Service Bulletin

SB 14-3
2-11-82

SUBJECT: FUEL HOSE CLAMPS
VEHICLES: ALL 308 MODELS

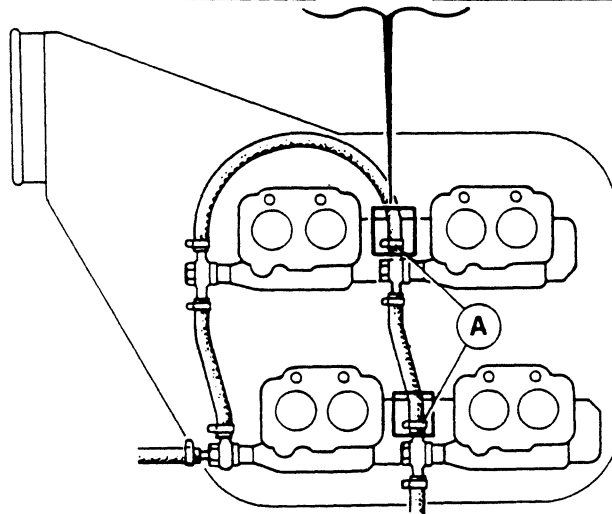
INFORMATION: When performing repairs to the fuel system, make sure hose clamps (A in diagram) are properly positioned, so that they do not interfere with the carburetor linkages (C).
